ADDENDUM NO 01

6/15/2021

Henderson Engineers, Inc.
8345 Lenexa Dr. Suite 300
Lenexa, KS 66214

PSU Weede Fieldhouse HVAC

COVER SHEET
A-014285
G0.00
100% BID
AND PERMIT

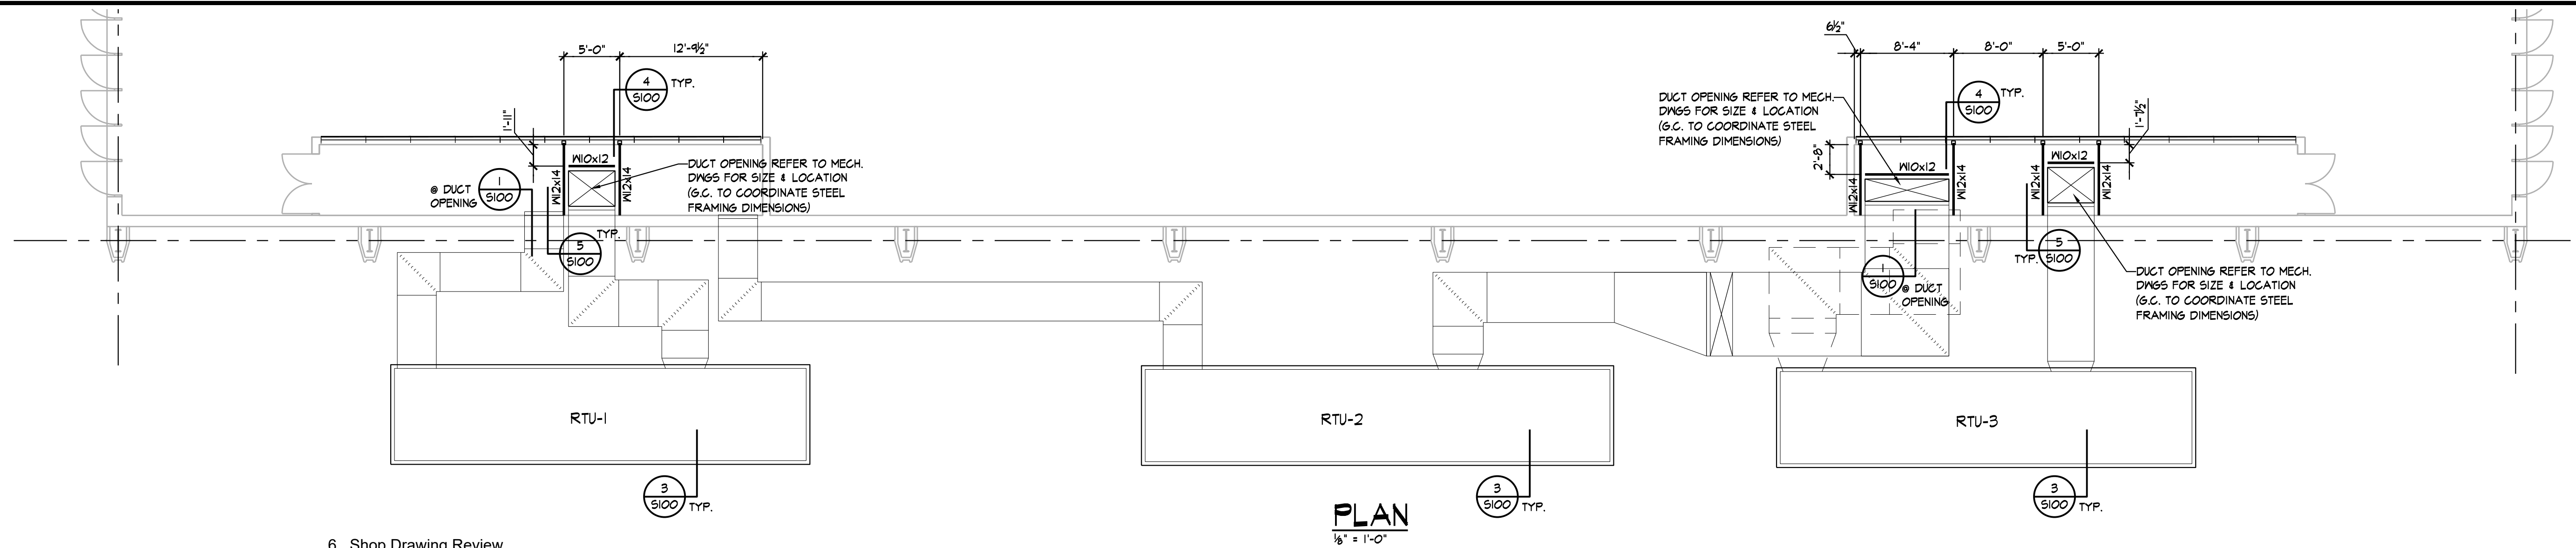
1. G0.00 – **ADD** note regarding floor protection.
2. S1.00 – **ADD** detail for light pole base.
3. E1.00 – ELECTRICAL SITE PLAN
 - A. **ADD** scope associate with site lighting relocation. Refer to revised sheet included in this addendum.
4. M1.01A & M1.01B – MECHANICAL HVAC PLAN
 - A. **REMOVE** bollards.

FLOOR PROTECTION

CONTRACTOR SHALL PROVIDE FLOORING PROTECTION. PSU TO FURNISH CARPETS TO CONTRACTOR. CONTRACTOR TO PROVIDE PLYWOOD. CONTRACTOR SHALL INSTALL CARPET WITH PLYWOOD OVERLAY TO PROTECT GYMNASIUM WOOD FLOOR. CONTRACTOR TO RETURN CARPET TO PSU.
